# Program Bulletin

## CUSTOMER SATISFACTION PROGRAM

**SUBJECT:** Front and Rear Door Handles May Stick or Bind

**MODELS:** 2013 Buick LaCrosse, Regal, Verano  
2013 Cadillac SRX  
2013 Chevrolet Cruze, Malibu  
Equipped with Keyless Entry Feature (ATH)

3415788

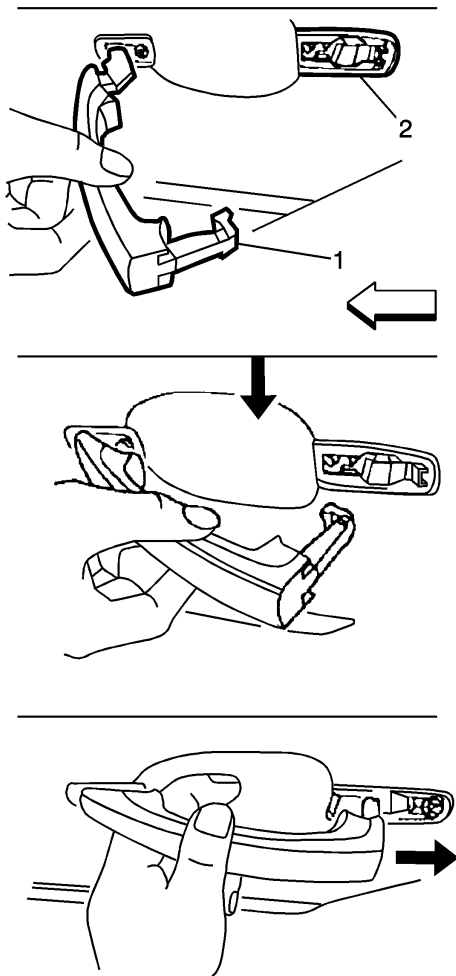
7. Measure the leg of the door handle as shown. Ensure the thickness is between 5.7 mm (0.224 in) and 5.9 mm (0.232 in).

- If the thickness is between 5.7 mm (0.224 in) and 5.9 mm (0.232 in), the door handle leg does NOT require modification. Proceed to step 8.

- If the thickness is greater than 5.9 mm (0.232 in), use a flat file or fine grade sand paper to remove material from the area identified by the arrows. Remove an equal amount from both sides of the door handle leg. The final thickness should be 5.7 mm (0.224 in). Proceed to step 8 after removing the appropriate amount of material from the door handle.

**Note:** Removing too much material may create a rattle condition. The final thickness should be 5.7 mm (0.224 in).
